VSH PREMIER CIRCLE ARB 2022-29

SUBMISSION OF FINAL SITE PLAN

June 21, 2022

PROJECT NARRATIVE

NEW - ELEVATIONS

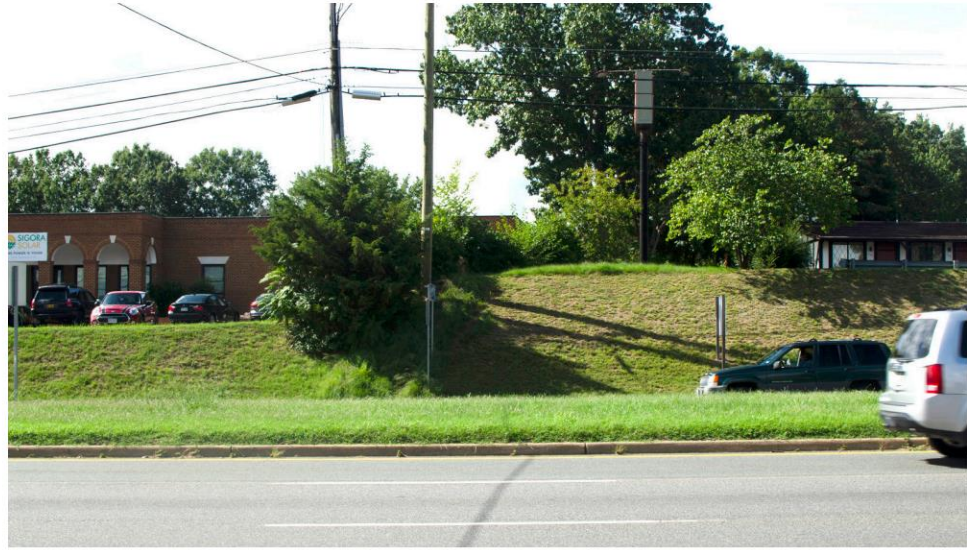
6. Revise the architectural drawings to note conformity with the updated window glass specifications. The updated specifications are visible light transmittance (VLT) shall not drop below 40%. Visible light reflectance (VLR) shall not exceed 30%.

GLAZING REQUIREMENTS
 VISIBLE LIGHT TRANSMITTANCE \geq 40%
 VISIBLE LIGHT REFLECTANCE \leq 30%

VISIBILITY OF ALL MECHANICAL EQUIPMENT FROM THE ENTRANCE CORRIDOR SHALL BE ELIMINATED
